Access Compliance Report Public Rights-of-Way (Curb Ramps)

Main Street: NEWPORT_AVE Cross Street: EL_CAMINO_LN Location: NE

ADA ID: RPRK211007131929 Ramp Type: Type 1 - Perpendicular Diagonal Initial Pass/Fail: Fail Overall Compliance: No Severity Score: 30

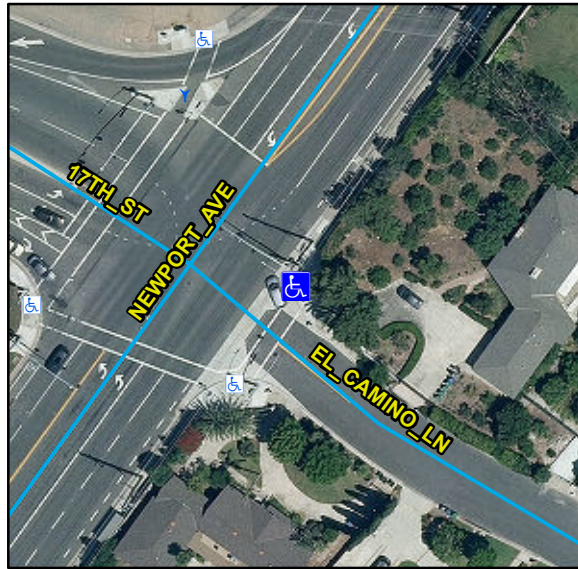
Compliance	Description	Data	Compliance	Description	Data
N/A	Ramp Length (in)	120	N/A	Flare Type LT	
Yes	Ramp Width (in)	48			N/A
No	Ramp Run Slope (%)	12.7	N/A	Flare Slope LT (%)	N/A
Yes	Ramp Cross Slope (%)	0.2	N/A	Flare Traversable LT	N/A
N/A	Landing Present	N/A	N/A	Flare Type RT	
N/A	Landing Length (in)	N/A			N/A
N/A	Landing Width (in)	N/A	N/A	Flare Slope RT (%)	N/A
N/A	Landing Run Slope (%)	N/A	N/A	Flare Traversable RT	N/A
N/A	Landing Cross Slope (%)	N/A	N/A	DWS Provided	N/A
N/A	Landing Movement Obstructed?	N/A	N/A	DWS Contrast	N/A
	Landing Movement Type	N/A	N/A	DWS Length (in)	N/A
N/A	Landing Shared	N/A	N/A	DWS Full Width	N/A
N/A	Clear Space	Yes	N/A	DWS Offset Left (in)	N/A
N/A	Clear Space To Crosswalk (in)	N/A	N/A	DWS Offset Right (in)	N/A
N/A	Marked Crosswalk 1	No	N/A	Marked Crosswalk 2	Yes
	Crossing 1 Direction	N		Crossing 2 Direction	W
	Marked Crosswalk 1 Width (in)	N/A		Marked Crosswalk 2 Width (in)	120

N/A	Ramp Inside Crosswalk 1	N/A	Yes	Ramp Inside Crosswalk 2	No
	Crossing 1 Slope (%)	11.5		Crossing 2 Slope (%)	1
	Crossing 1 Cross Slope (%)	4.9		Crossing 2 Cross Slope (%)	0.7
N/A	Gutter Ponding	N/A	No	Curb Slope	15.9
Yes	Gutter Lip Height (in)	0		Road Run Slope (%)	5.5
N/A	Gutter Run Slope (%)	N/A		Road Cross Slope (%)	9.8
N/A	Gutter Cross Slope (%)	N/A			
Yes	Overall Surface Condition: Acceptable		Yes	Perp Joint Present	Yes
	Cross Gutter Present?	Yes		Spandrel Present?	Yes
	Replace Cross Gutter?	No		Replace Spandrel?	No

Remove & Replace Curb Ramp With Two New Directional Ramps or Equivalent. Restripe Crosswalk.
